UNITED STATES
NUCLEAR REGULATORY COMMISSION
WASHINGTON, D. C. 20555

APPLICANT: Public Service Electric & Gas Company (PSE&G)
FACILITY: Hope Creek Generating Station
SUBJECT: SUMMARY OF STRUCTURAL AND GEOTECHNICAL ENGINEERING
BRANCH (SGEB) MEETING

On August 1, 1984, a meeting was held in the Bethesda, Maryland offices of the NRC to discuss the remaining SGEB-Structural audit open items identified in the Draft SER. A list of meeting attendees is included as Enclosure 1 to this meeting summary.

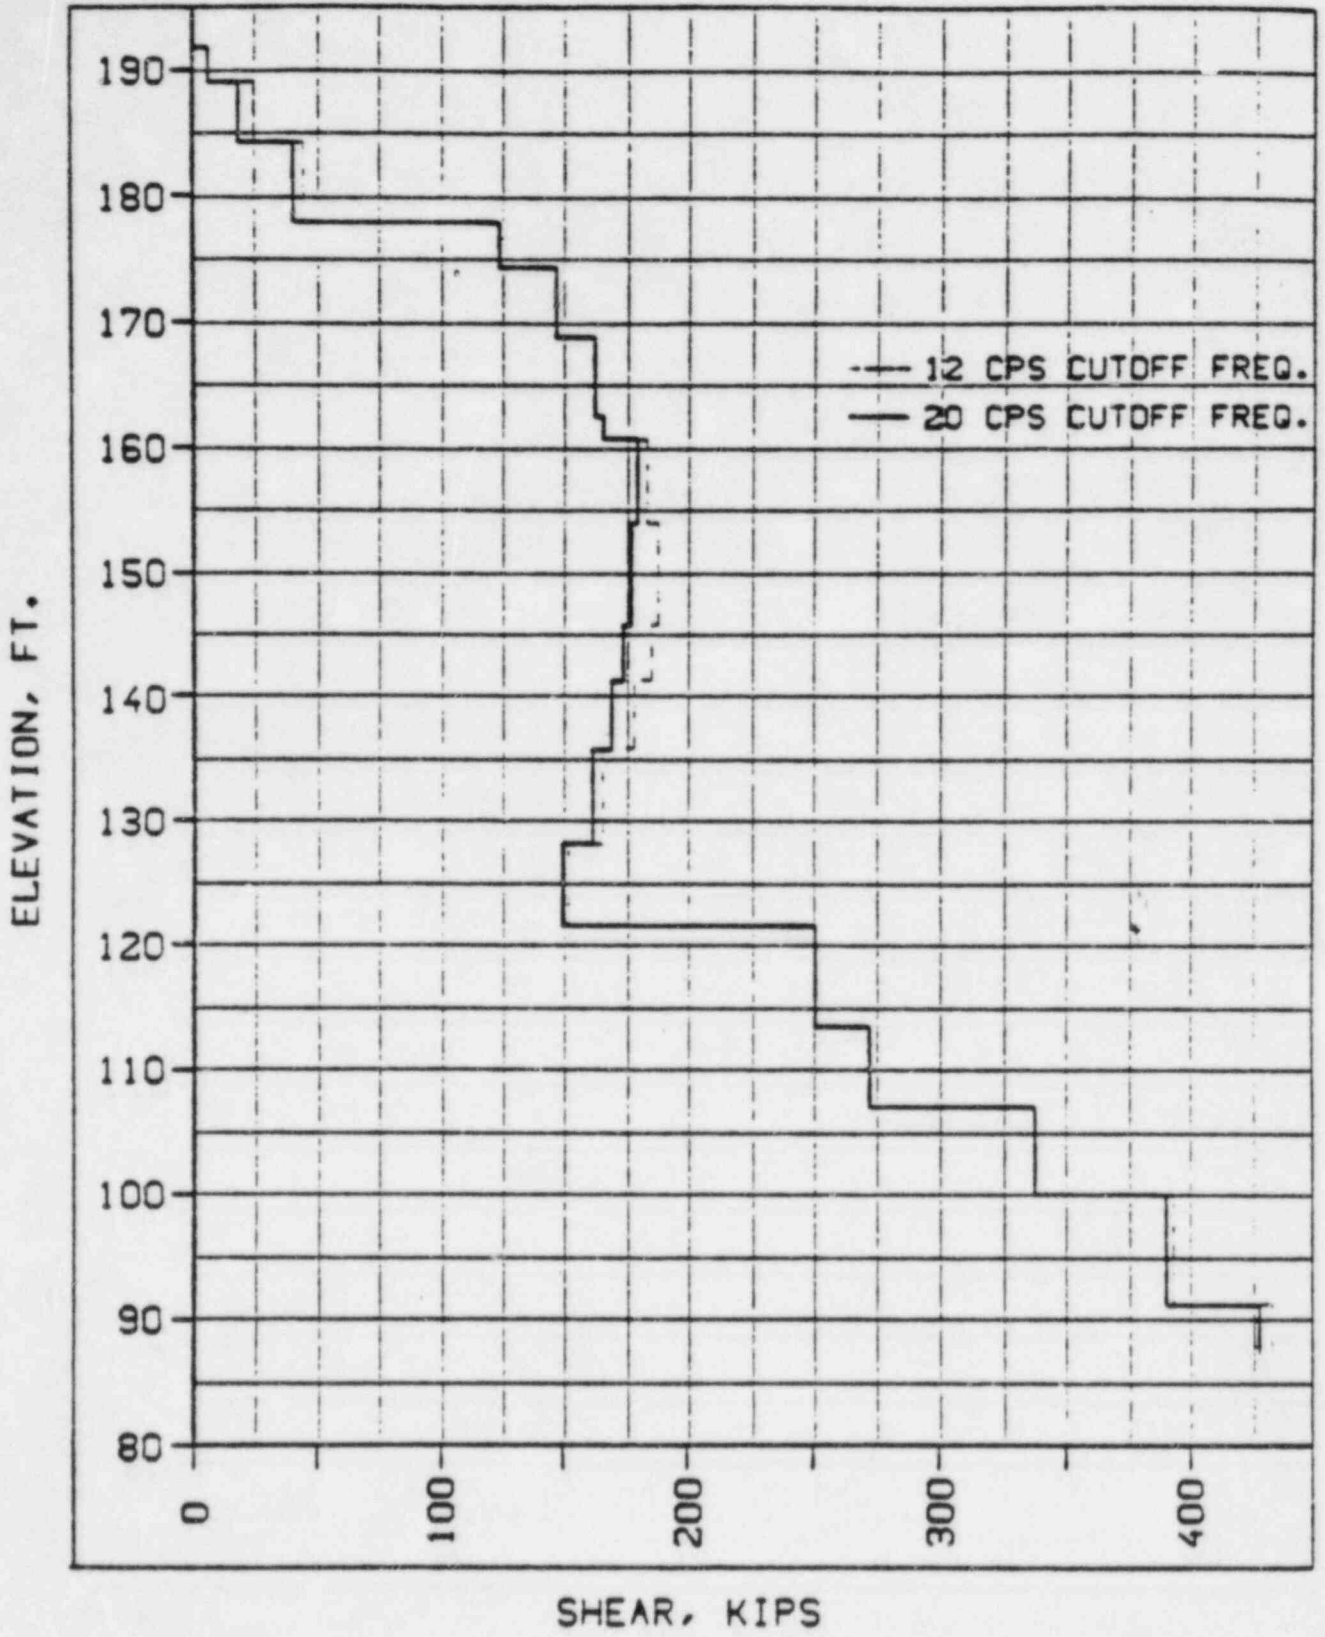
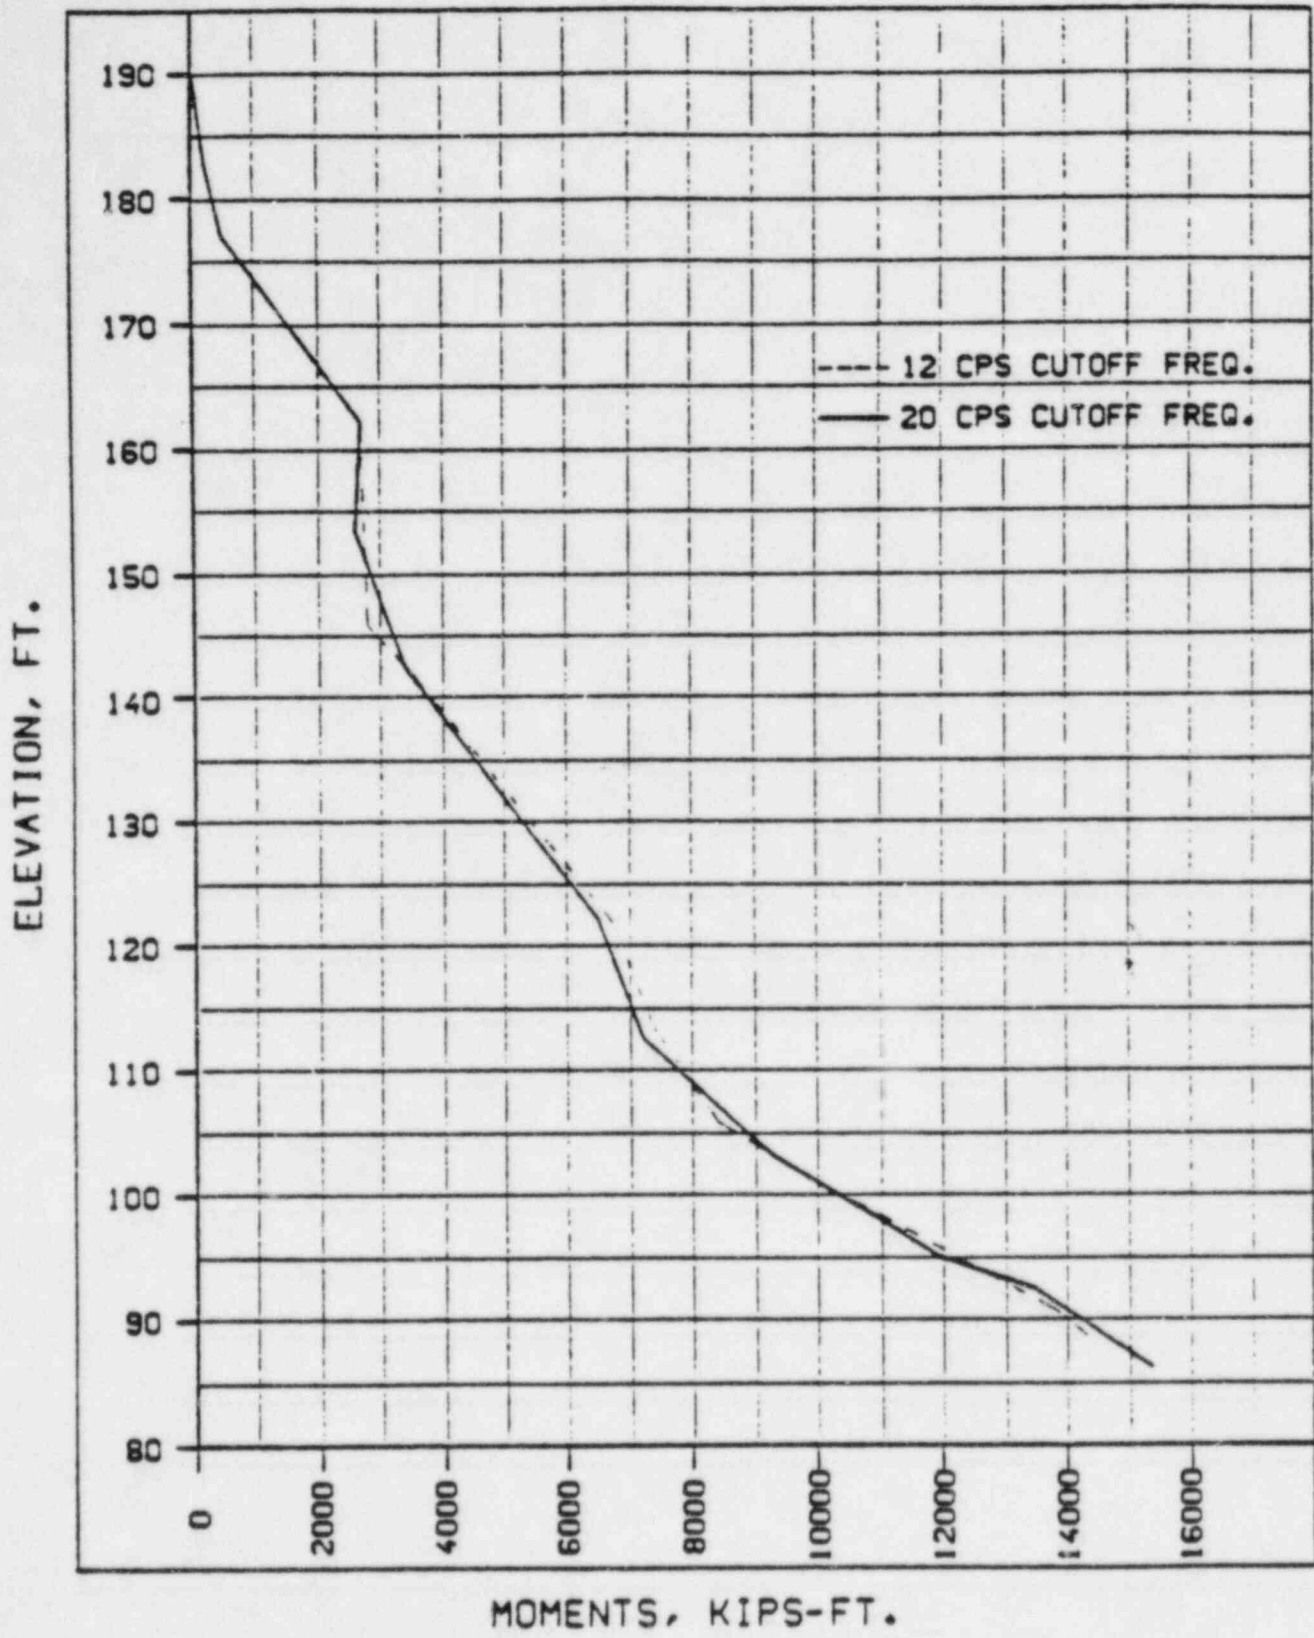
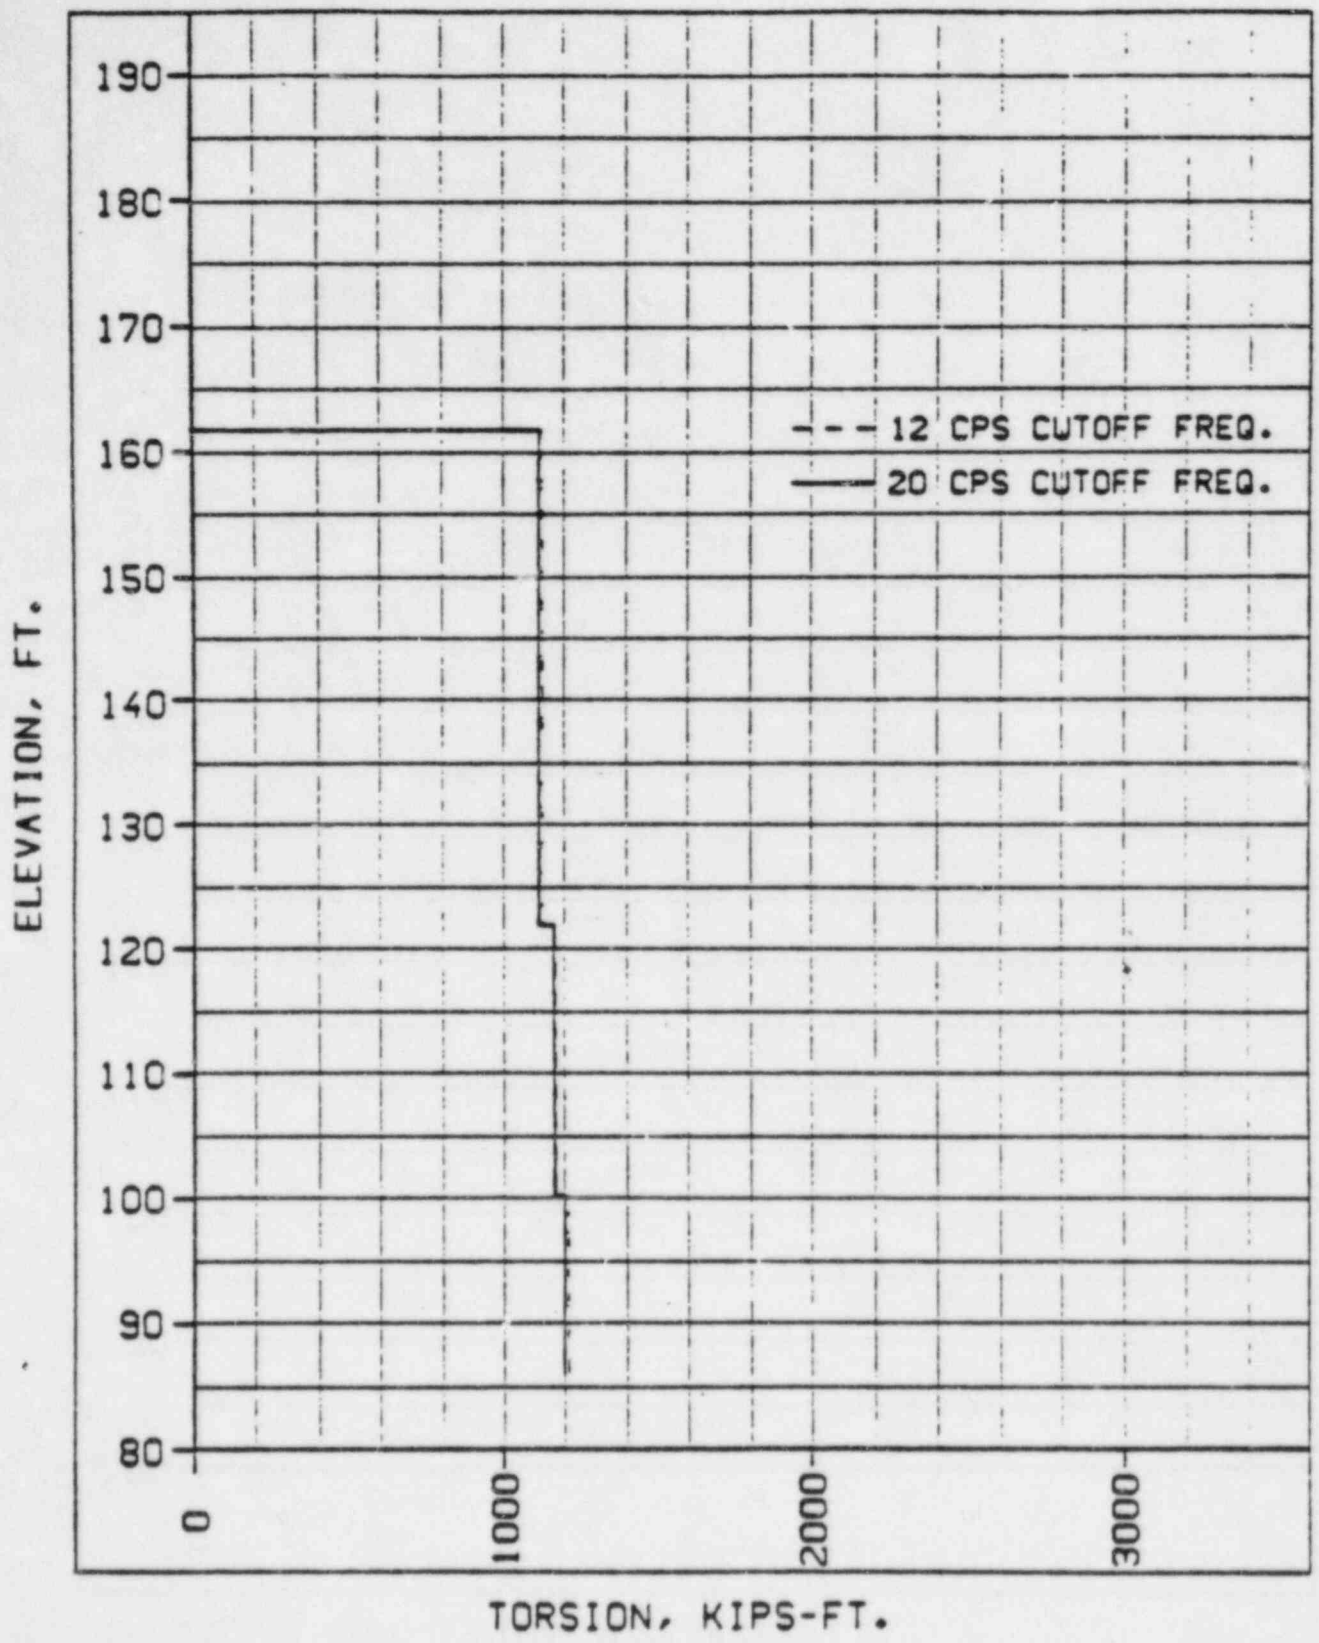
QUESTION: Justify the 12 Hz. cut-off frequency for SSI analysis.

Figures 6 through 8 present response maxima for shear, moment and torque in the drywell of the Reactor Building, when subjected to each of the base mat excitations. The drywell was selected for comparison of cut-off frequency effects because it is a portion of the reactor pressure boundary, and the design of this structure is particularly critical. The comparison of results for the drywell is representative of other portions of the structure as well. As can be seen from these plots, the response maxima of the structure are virtually independent of the high frequency acceleration components of the base mat motion. Clearly the shear, moment and torque response values for the structure are essentially identical for the two different cut-off frequencies, indicating a dependence only on the low and mid frequency range of the base mat motions.
